SUBJECT: REDISTRIBUTION OF TECHNICAL SPECIFICATION PAGES FOR AMENDMENT
NOS. 180 AND 181 - BROWNS FERRY NUCLEAR PLANT, UNIT 2 (TAC NOS.76902
AND 76934)

ATTACHMENT TO LICENSE AMENDMENT NO. 180

FACILITY OPERATING LICENSE NO. DPR-52

ATTACHMENT TO LICENSE AMENDMENT NO. 181

APRM Flow Reference Scram and APRM Rod Block Settings
Fig. 2.1-1

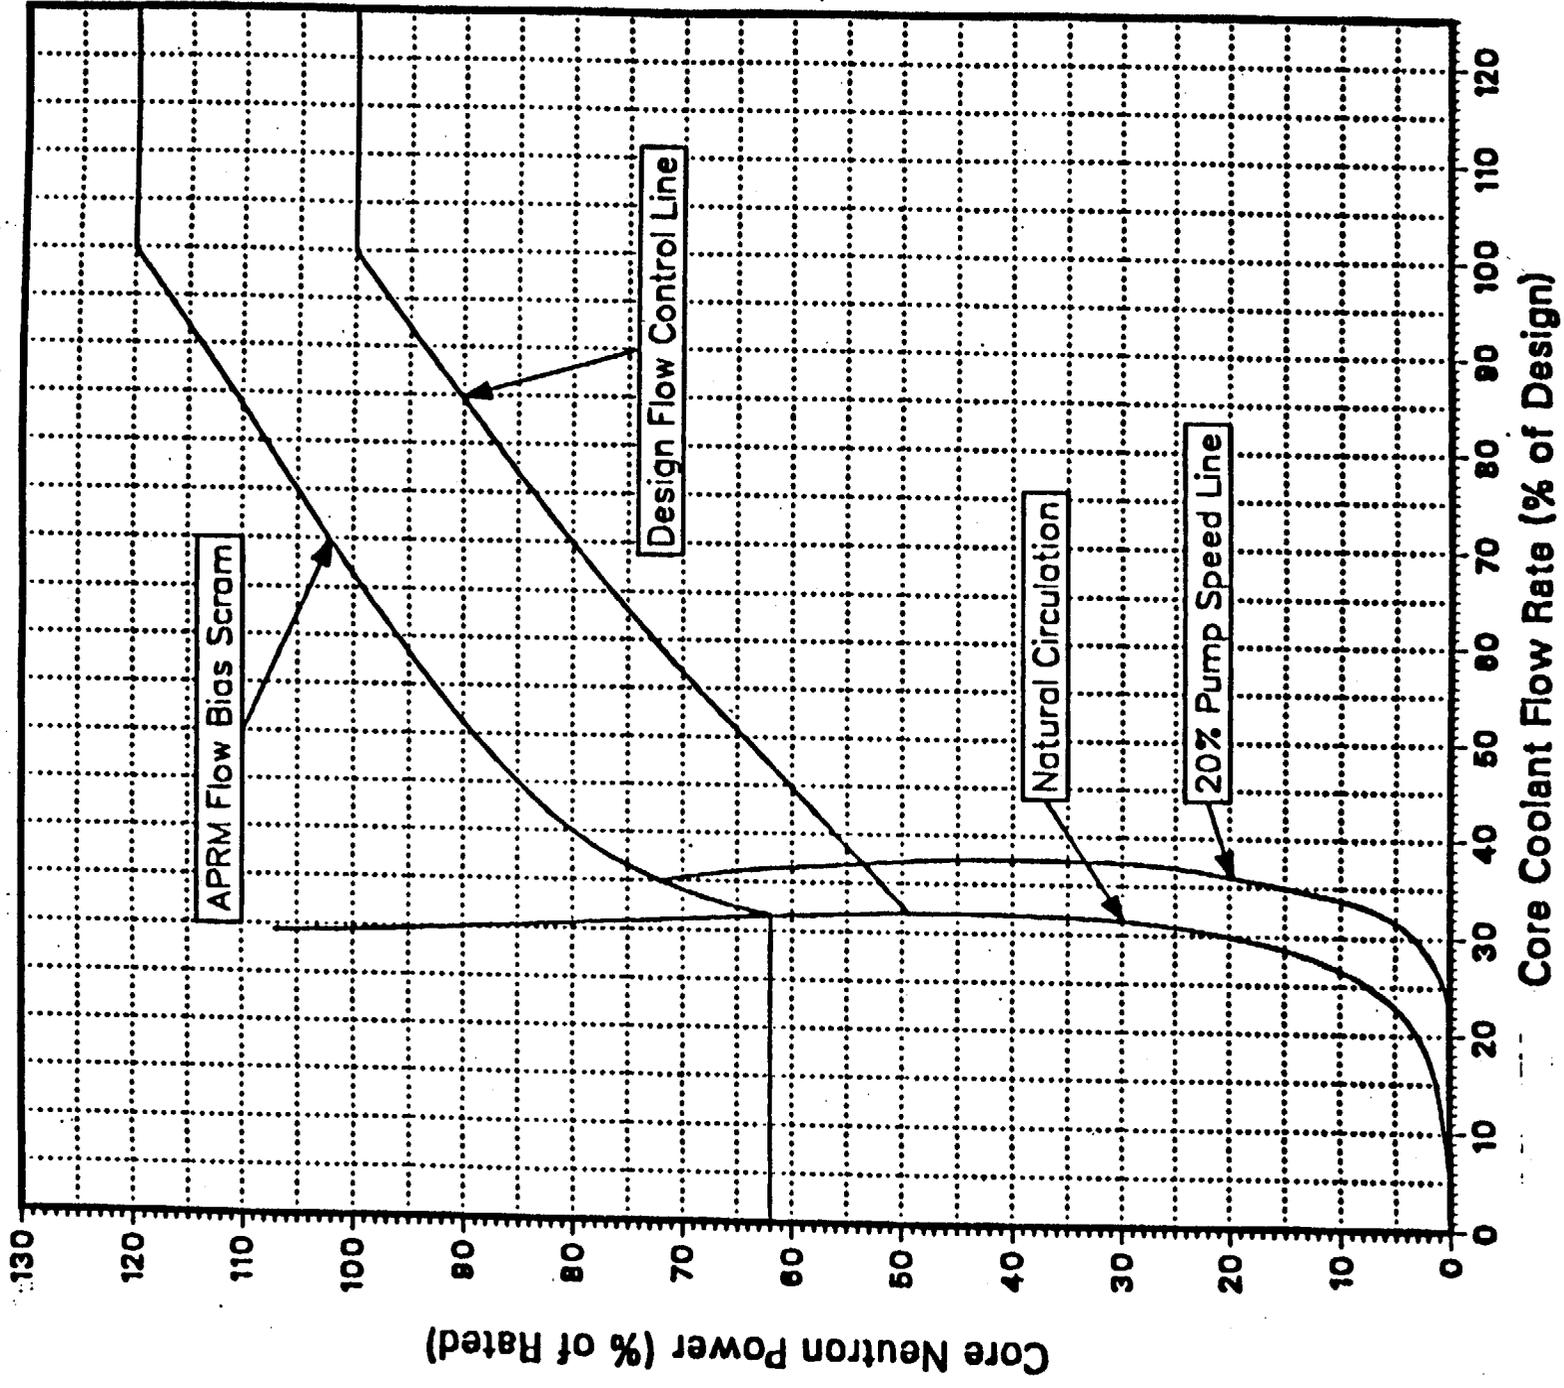
- d. Fixed High Neutron Flux Scram Trip Setting--When the mode switch is in the RUN position, the APRM fixed high flux scram trip setting shall be:

$\leq 120\%$ power.
2. APRM and IRM Trip Settings (Startup and Hot Standby Modes).
 - a. APRM--When the reactor mode switch is in the STARTUP position, the APRM scram shall be set at less than or equal to 15% of rated power.
 - b. IRM--The IRM scram shall be set at less than or equal to 120/125 of full scale.
